Service Advisory

W-155

TRACTOR

Subject: A "ratcheting" sound is heard and felt in the steering wheel.

FIGURE 1

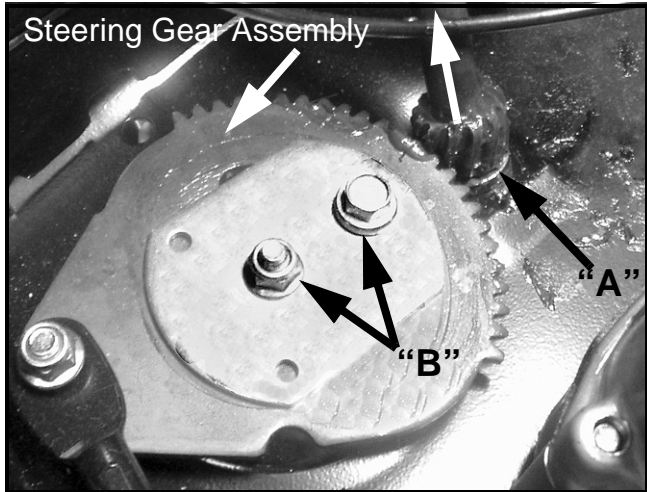
1. Place the tractor on a flat and level surface, turn off the engine, remove the ignition key, set the parking brake ON and set the front wheels so that they are facing straight forward.
2. Allow engine and muffler to cool before proceeding.
3. Raise the hood and check the items A through D: Refer to Figures 1 and 2.

B.) The steering gear assembly mounting hardware are present and tight.

A.) The steering shaft is properly seated in the hex flange bushing in the frame and does not pull up and out of the hex flange bushing.

D. Inspect the teeth on the steering gear assembly and on the steering shaft. If there is wear allowing the steering gears to skip a tooth when steering, install service kit **753-05746** (see attached instruction sheet).

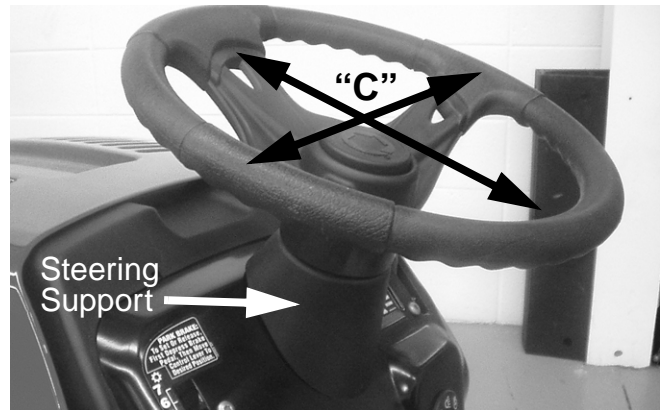
C.) Gently move the steering wheel forward and back and from side to side. If there is significant movement in the steering shaft **without** the plastic steering support moving, there is excess wear in the steering support and should it be replaced. See Figure 2.
